Facility: Parking Plaza

Address: 17 N. 8th Street

Date of Survey: 02/02/10 & 02/08/10

The Parking Plaza structure has four parking levels, all of which are sloped slabs averaging approximately 6%. The parking structure was constructed prior to the 1990 Americans with Disabilities Act and all levels are accessible via two elevators. This structure has a total of 349 parking spaces and therefore, per ADAAG 4.1.2 (5) a. – d., eight total accessible parking spaces are required.

A3

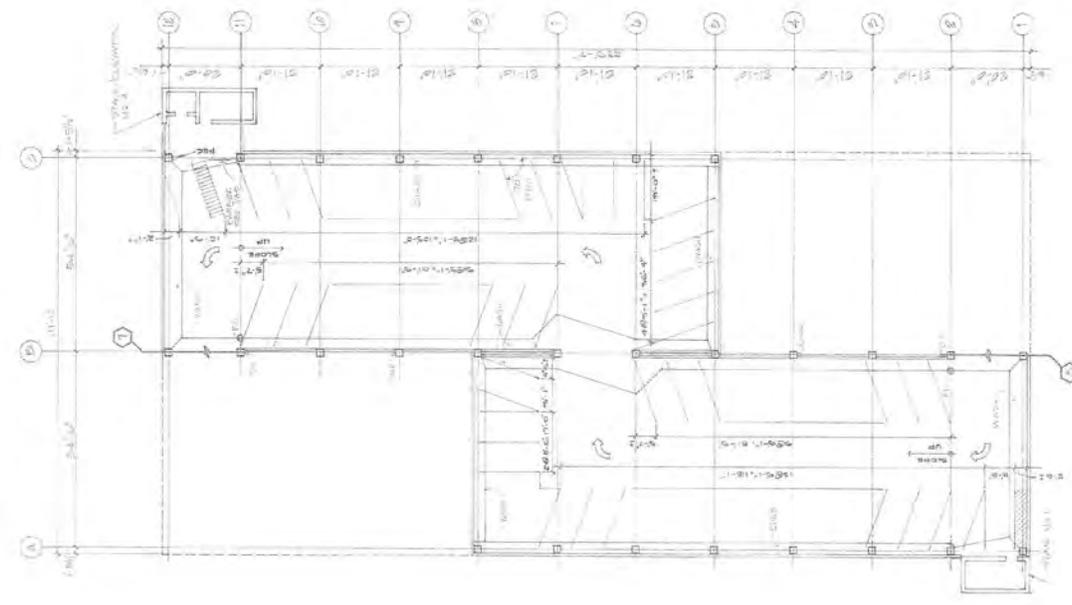
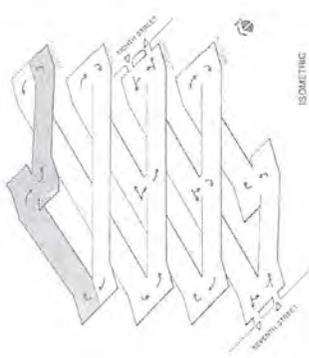
- At SW Level 2 elevator landing and SW Level 3 elevator landing, scarify existing concrete beyond the 2' deep level landing to allow for a concrete topping to extend landings to be level out 4' from the elevator entrances and then continue concrete topping out to front edge of accessible parking spaces. Add a contrasting truncated dome detectable warning surface at ramp outlet into the parking area (see Area A & B on plans). **Estimated Cost: \$4,488.00**

- Parking Area 1 (see plans): Restripe two spaces to be minimum 8' wide with a shared min. 5' wide access aisle and raise signs to 72" above grade.
Estimated Cost: \$328.00

- Parking Area 2: Restripe existing space such that a min. 5' wide access aisle is located on the left side of a min. 8' wide parking space and raise parking sign to 72" above grade.
Estimated Cost: \$212.00

- Parking Area 3: Restripe existing space such that a min. 5' wide access aisle is located on the right side of a min. 8' wide parking space.
Estimated Cost: \$288.00

- Parking Area 5: Restripe existing space such that a min. 5' wide access aisle is located on the left side of a min. 8' wide parking space.
Estimated Cost: \$192.00

- Parking Area 6: Restripe existing space such that a min. 5' wide access aisle is located on the left side of a min. 8' wide parking space.
Estimated Cost: \$288.00

- Parking Area 7: Restripe existing space such that a min. 5' wide access aisle is located on the left side of a min. 8' wide parking space and install parking sign on a post to raise to 72" above grade.
Estimated Cost: \$359.00

- Add truncated dome detectable warning surface at existing curb-cuts located adjacent to parking areas 1 & 2.
Estimated Cost: \$792.00
- Patch to eliminate ¾" change in level at curb-cut adjacent to parking area 2.
Estimated Cost: \$100.00

- Install new curb-cut at parking area 3 & 4 and replace curb-cut at parking area 7:
Estimated Cost: \$7,500.00

- Install a barrier rail meeting ADAAG 4.4.2 at the open underside of four interior stairs (C, D, E & F on the plans). **Estimated Cost: \$670.00**
